# PEER REVIEW CONCEPT

# Peer Review Concept Design

# Peer Review Concept Design

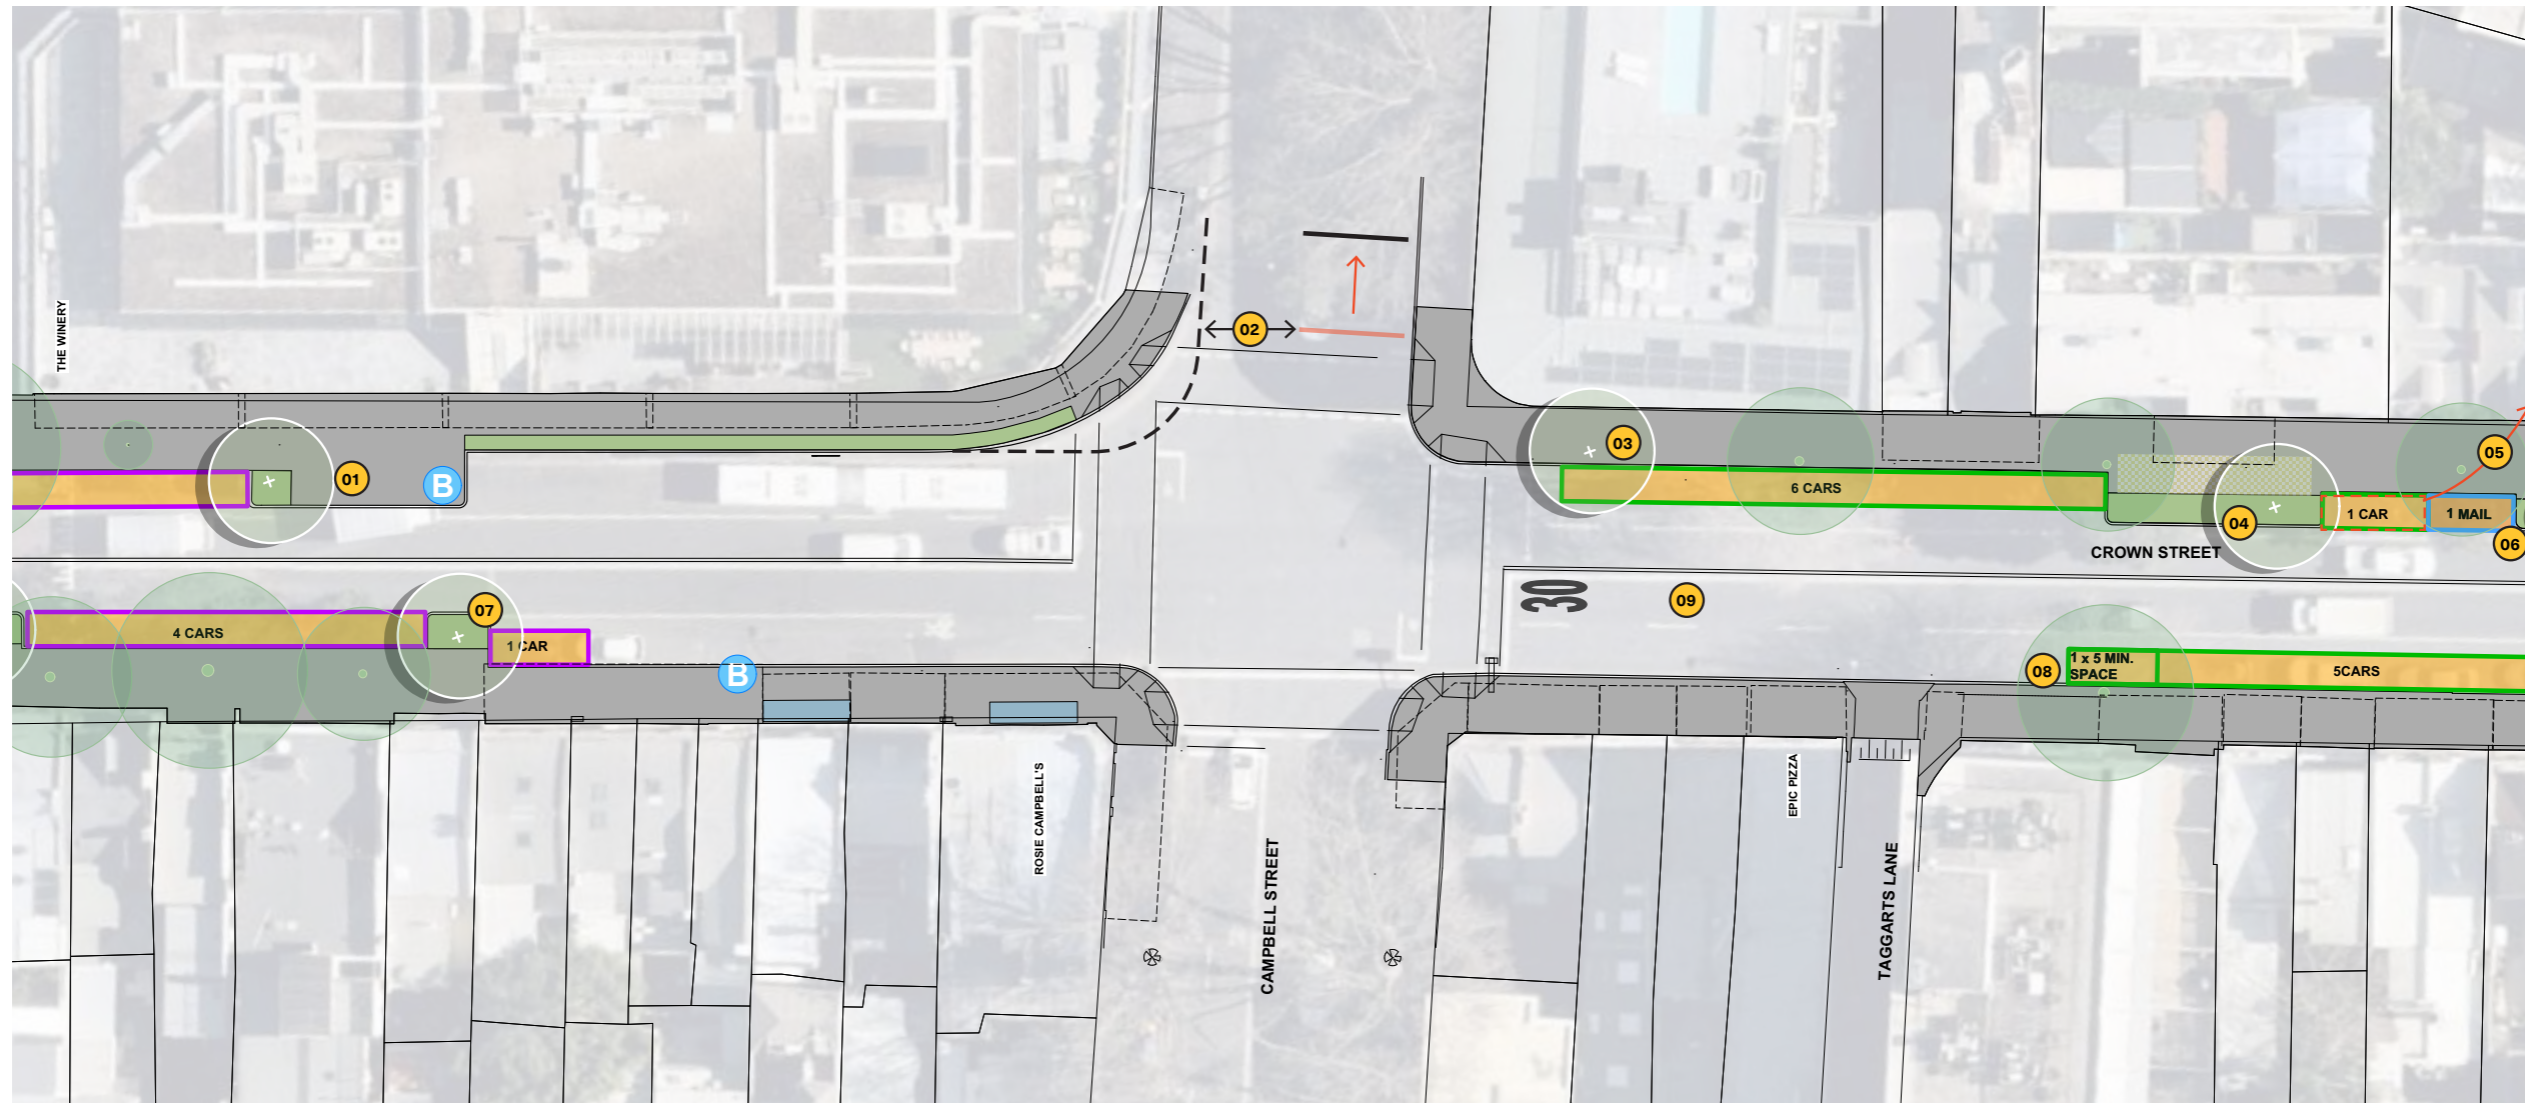
1. New kerb extension for in-lane bus stop to alleviate constrained footpath space where bus stop furniture is currently installed. New planting bed and street tree provided within kerb extension.
2. Explore potential for traffic stop line relocation on Campbell St to allow for kerb radius reduction without impeding vehicle turning movements.
3. New street tree in tree pit.
4. New kerb extension to create activation area with kerbside planting and additional street tree at existing commercial premises.
5. Relocate 1 no. existing car share parking space to Goulburn St (refer to next sheet for location of new car share space).
6. Existing mail parking space retained.
7. New street tree in kerb extension.
8. Convert existing no parking area to 1 no. 5 minute P line marked parking space.
9. Speed reduction to Crown Street to 30km/h (subject to TfNSW approval).

# Peer Review Concept Design

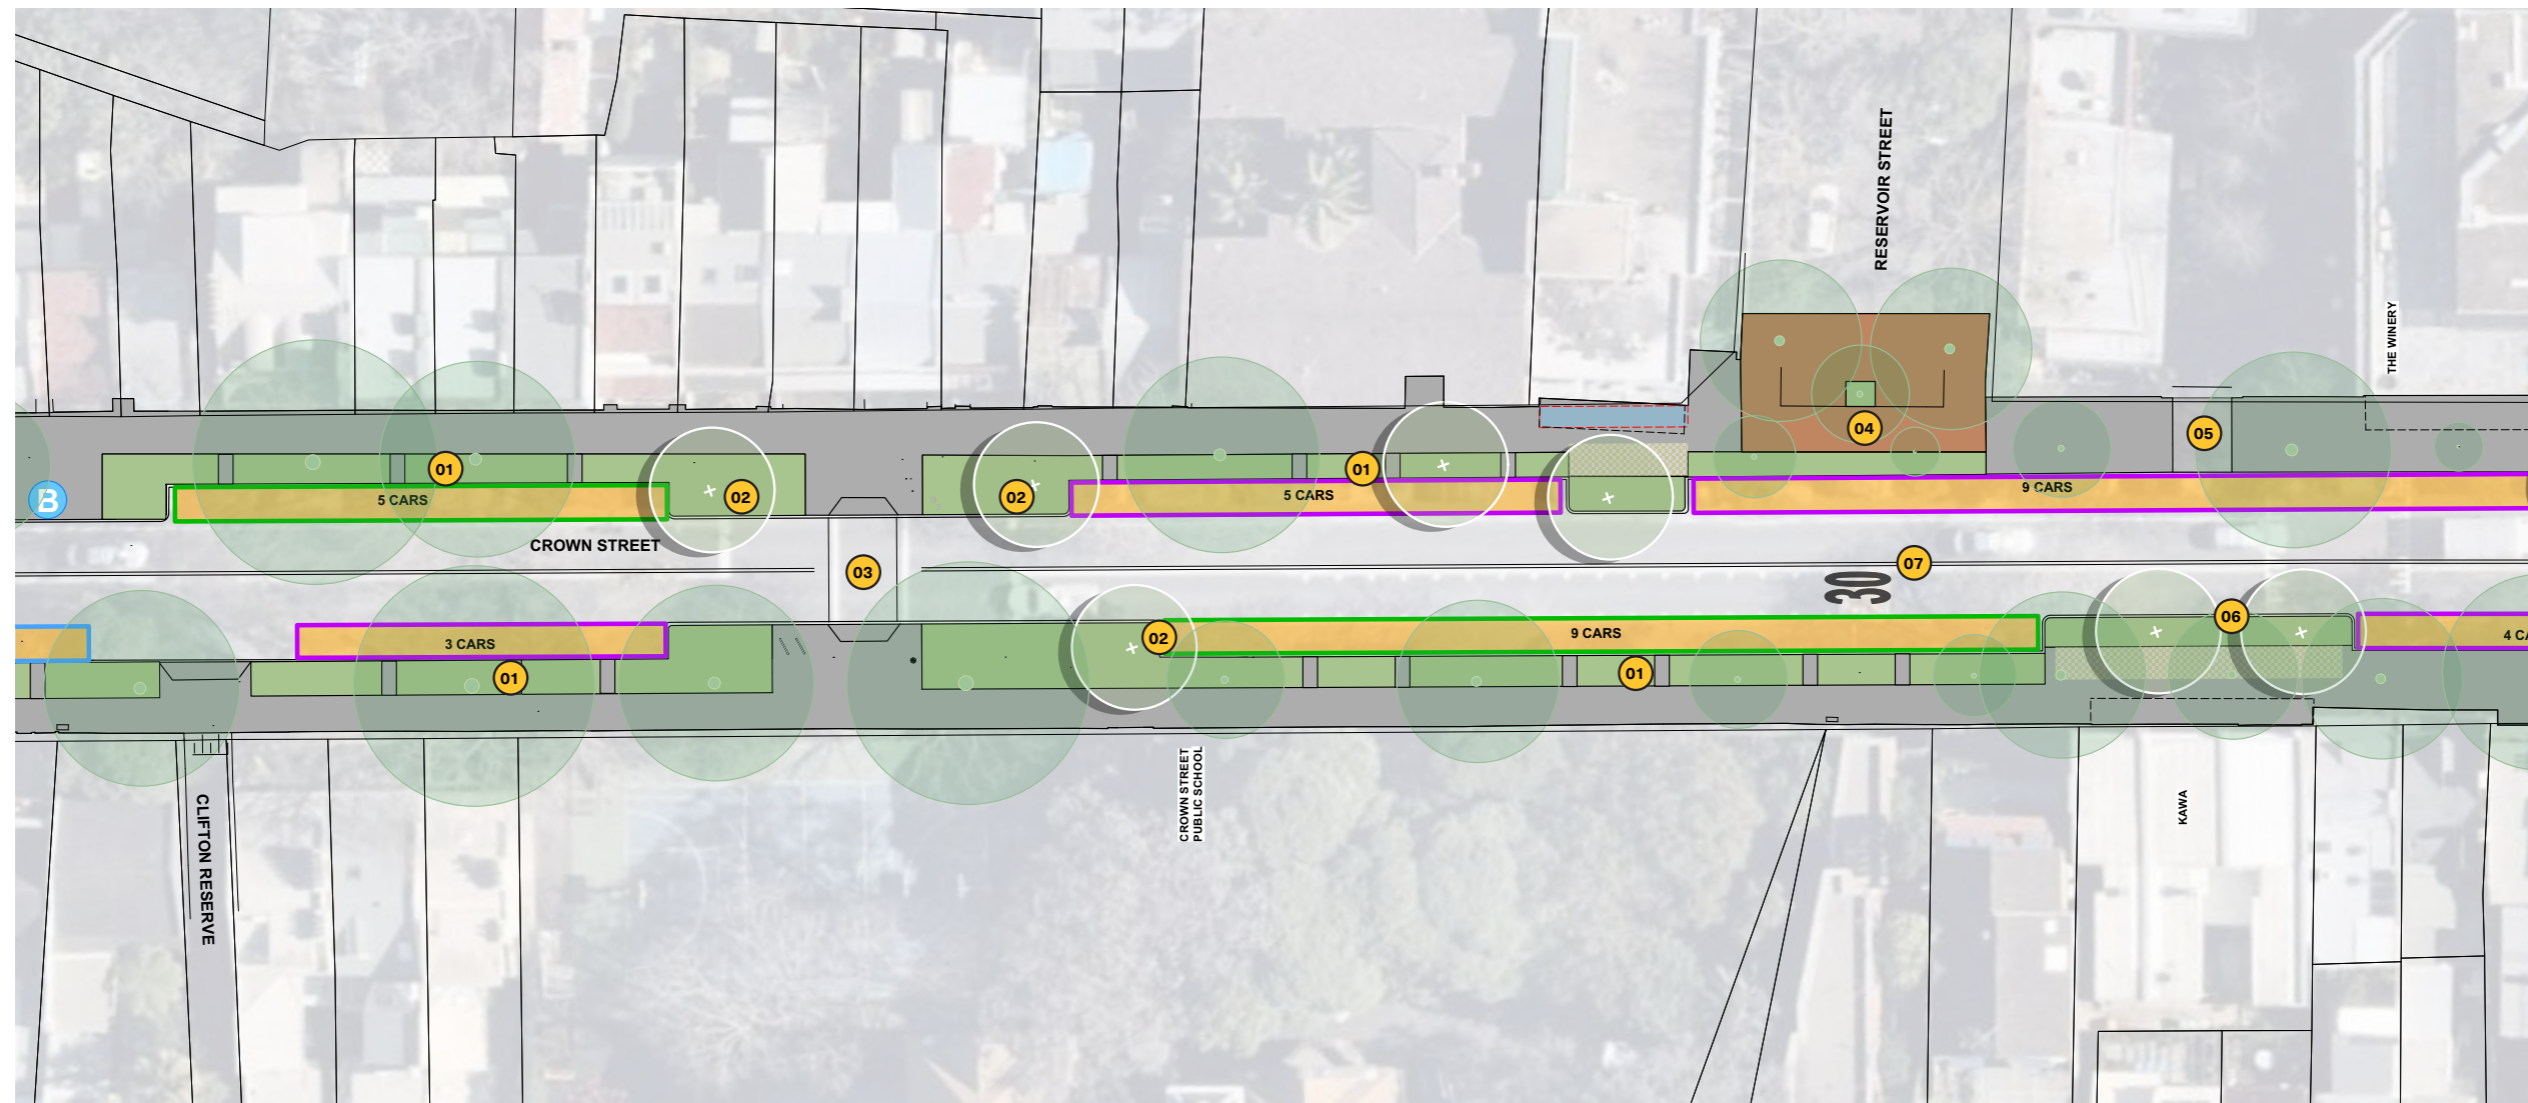
1. Kerb alignment adjusted (to minimum compliant parking space width) to maximise footpath and planting space. Continuous planting bed provided with intermittent pavements for access to parked vehicles.
2. New kerb extension with planting and street trees to provide additional canopy cover.
3. Existing signalised crossing retained in current location.
4. Existing brick paving to full width of Reservoir St lot boundary to be retained.
5. Existing heritage driveway retained.
6. New kerb extension to create activation area with kerbside planting and additional street trees at existing commercial premises.
7. Speed reduction to Crown Street to 30km/h (subject to TfNSW approval).

# Peer Review Concept Design

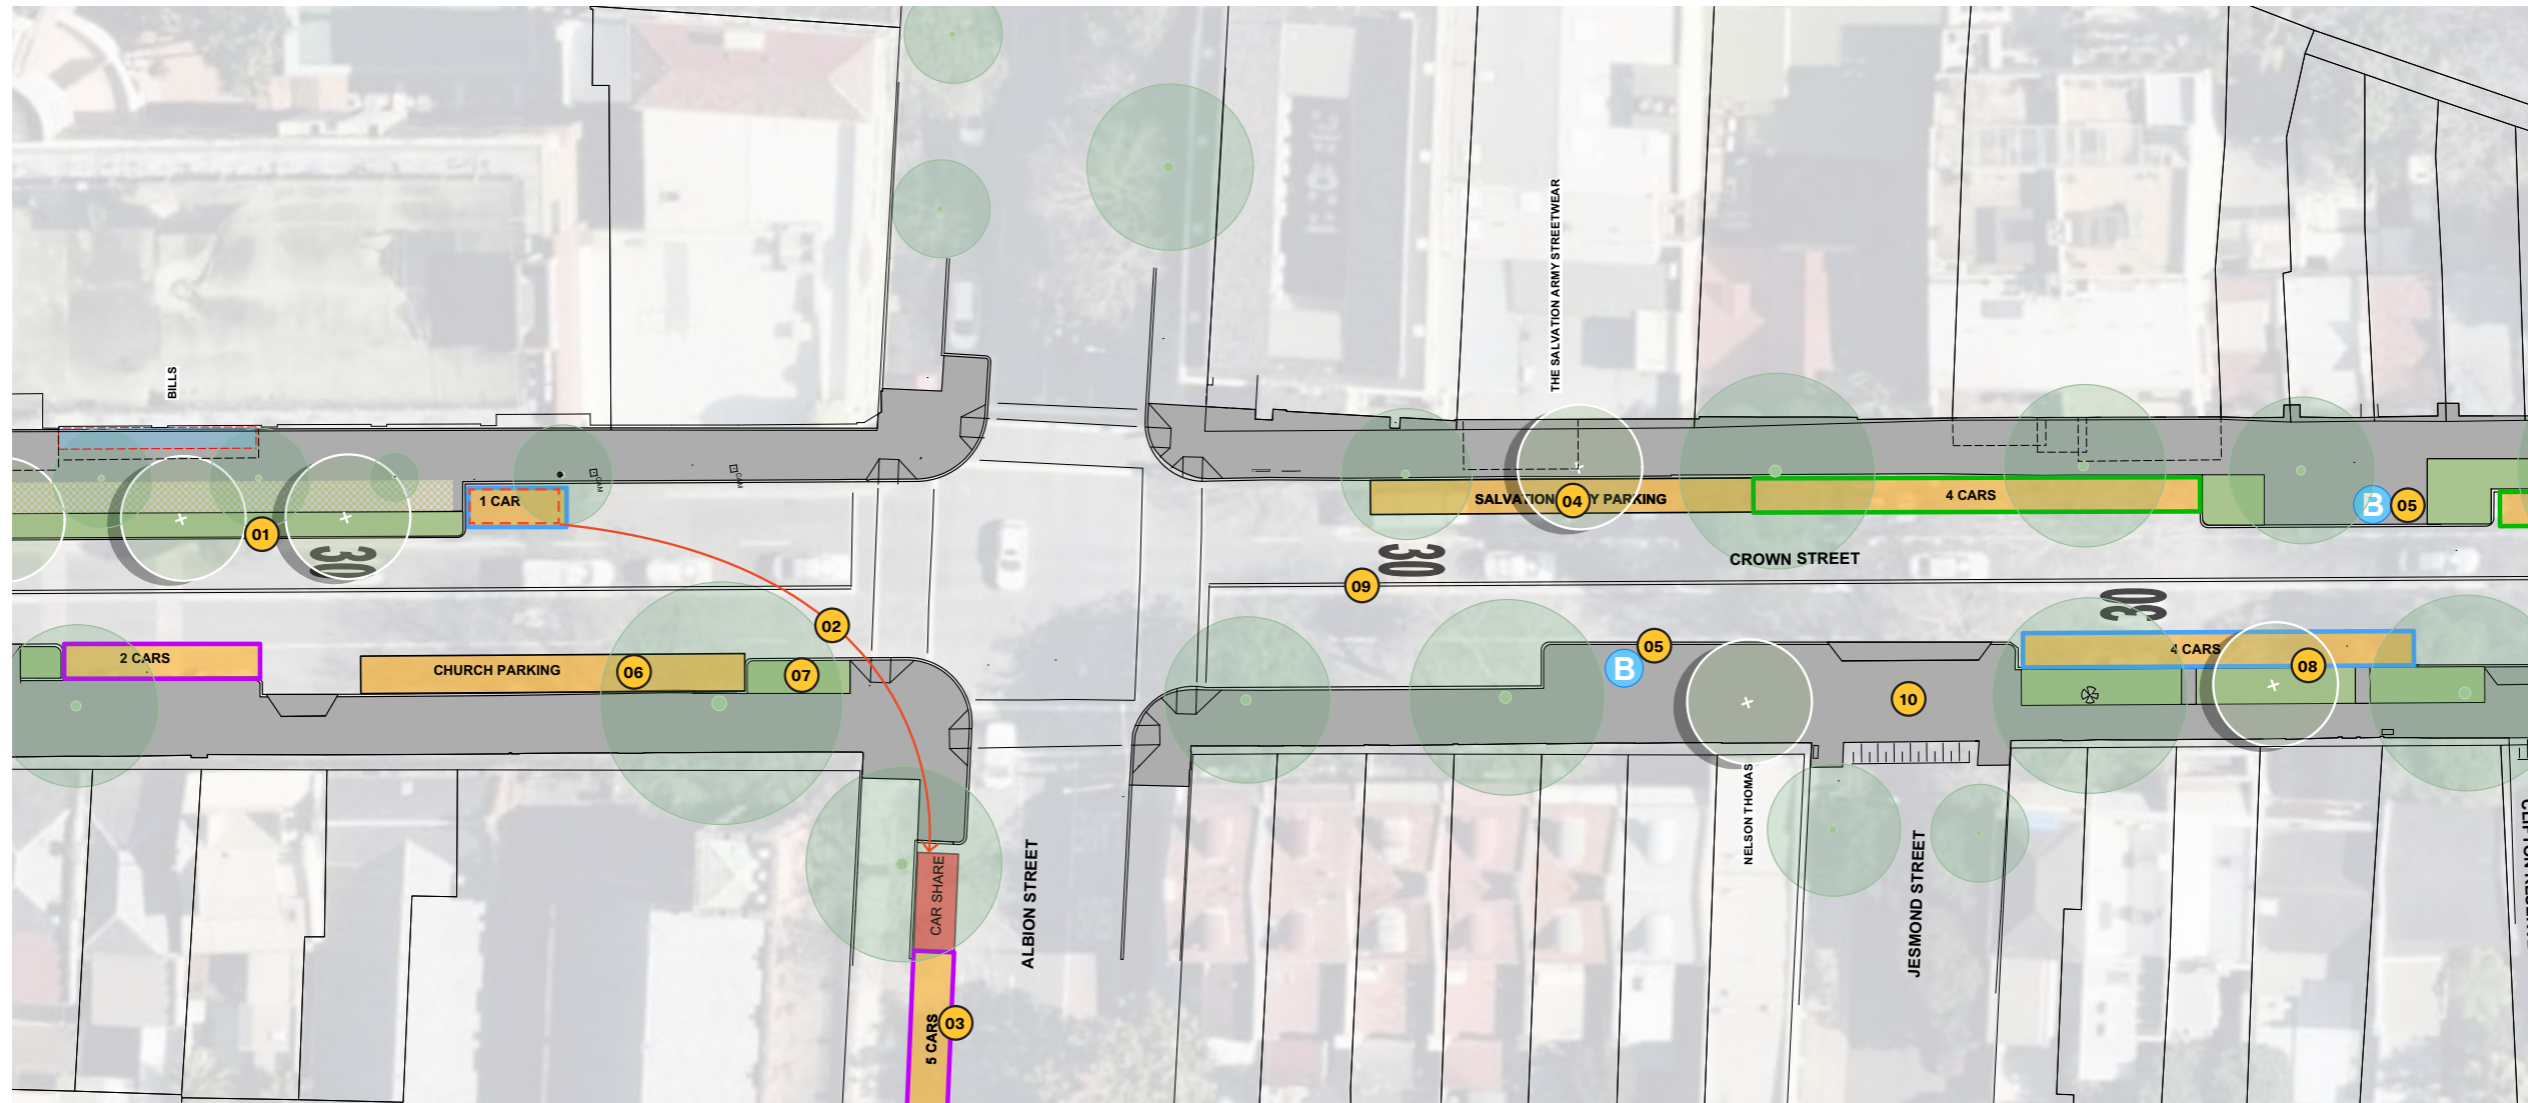
1. New kerb extension to create activation area with kerbside planting and additional street trees at existing commercial premises.
2. 1x car share relocated to Albion St, replaced with 2P parking space.

3. Convert 6 no. existing unmarked 2P parking spaces on Albion St to 5 no. marked 2P parking spaces.
4. Existing Salvation Army parking area. Investigate opportunity to introduce Loading Zone and/or after-hours general parking (subject to further consultation).

5. New kerb extension for in-lane bus stop, 9m paving zone shown, to be reviewed at detailed design stage to consider user access requirements (subject to approval by TfNSW).

6. Existing signed church parking area. Investigate opportunity to introduce timed after-hours general parking (subject to further consultation).
7. Kerb extension to provide additional pedestrian paving and planting at intersection.

8. Kerb alignment adjusted (to minimum compliant parking space width) to maximise footpath and planting space. Continuous planting bed provided with intermittent pavements for access to parked vehicles.

9. Speed reduction to Crown Street to 30km/h (subject to TfNSW approval).
10. Continuous footpath treatment and kerb extension at Jesmond St.
